Item No. 8b
Regular Action

PROJECT LOCATION
225 California Drive

Meeting Minutes Planning Commission

- a. 225 California Drive, zoned HMU - Design Review for an application for Environmental Review, Commercial Design Review, and Special Permit for building height for a new 4-story commercial building (DLC 225 California, applicant; The Jewell Partners, property owner; MBH Architects, architect) (172 noticed) Staff Contact: Kevin Gardiner

TREE PLANTING WITH BUBBLER IRRIGATION

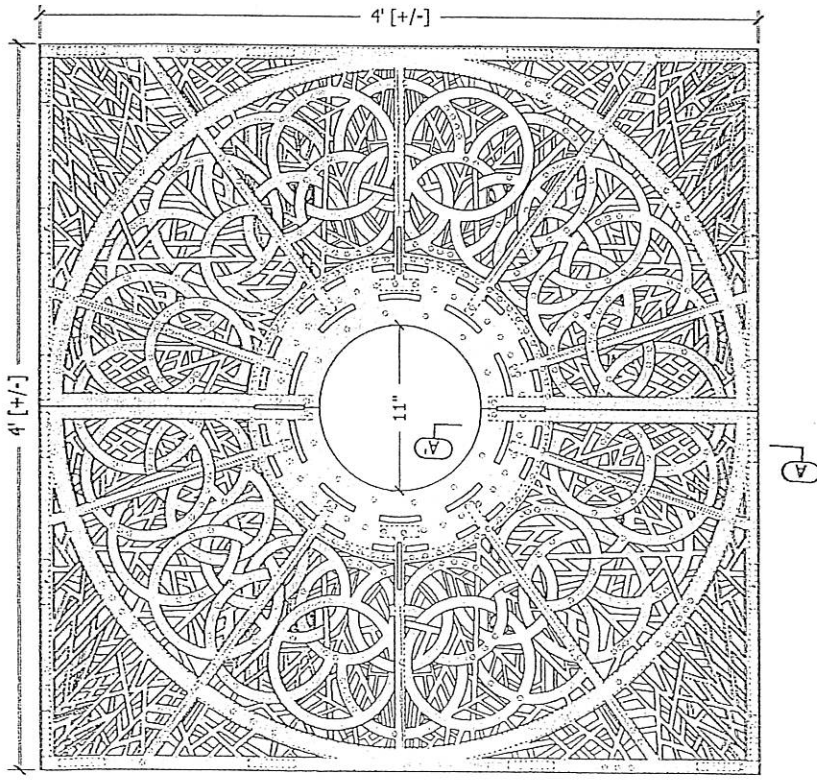
- ① Landscape plan is required to meet "Water Conservation in Landscape Regulations" (attached). Irrigation Plan required for Building permit. Audit due for Final.
- ② Street trees shall be 24" Quercus coccinea.
- ③ Provide staking and irrigation to street trees as per detail (attached)
- ④ Use City standard tree grate (attached)
